APPLICATION NO.	FILING DATE	FIRST NAMED INVENTOR	ATTORNEY DOCKET NO.	CONFIRMATION NO.
10/552,212	11/01/2005	Josef Guttenbrunner	P/3240-104	6755
	7590 12/18/200 FABER GERB & SOF	EXAMINER		
1180 AVENUE OF THE AMERICAS			KERNS, KEVIN P	
NEW YORK, NY 100368403			ART UNIT	PAPER NUMBER
			1793	
			MAIL DATE	DELIVERY MODE
			12/18/2008	PAPER

Application No.	Applicant(s)				
Office Action Occurrence	10/552,212	GUTTENBRUNNER ET AL.				
Office Action Summary	Examiner	Art Unit				
	Kevin P. Kerns	1793				
The MAILING DATE of this communication app Period for Reply	ears on the cover sheet with the c	orrespondence address				
A SHORTENED STATUTORY PERIOD FOR REPLY IS SET TO EXPIRE 3 MONTH(S) OR THIRTY (30) DAYS, WHICHEVER IS LONGER, FROM THE MAILING DATE OF THIS COMMUNICATION. - Extensions of time may be available under the provisions of 37 CFR 1.136(a). In no event, however, may a reply be timely filed after SIX (6) MONTHS from the mailing date of this communication. - If NO period for reply is specified above, the maximum statutory period will apply and will expire SIX (6) MONTHS from the mailing date of this communication. - Failure to reply within the set or extended period for reply will,

All of the mentioned components are shown in the figure below (Figure 1 of Fukase et al.) generated by examiner for clarification.

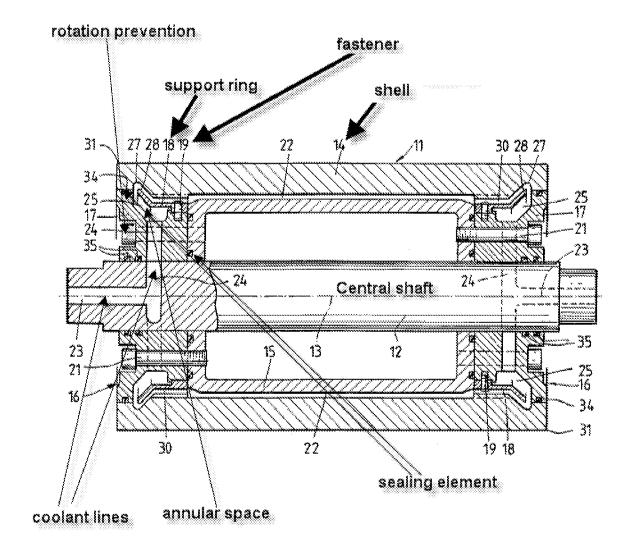
a central shaft 12 with a roll shell (outer circumferential wall 14) – see Figure 1; support rings 18 on the shaft 12 supporting the roll shell 14, with the shaft 12, the roll shell 14, and the support rings 18 being shaped to define an annular space which is axially delimited by the support rings 18 and is formed between the shaft 12 and the roll shell 14 (Figure 1);

Furthermore, Fukase et al. disclose sealing elements arranged between the support rings 18 and the shell 14 and between the support ring 18 and the shaft 12 (Figure 1).

The conduit lines are in the axis of the shaft 12 and the annular space.

Fukase et al. disclose a rotation-preventing device passing along the annular space to secure the shell 14.

The central shaft 12 has opposite end regions for supplying and discharging coolant (Figure 1).
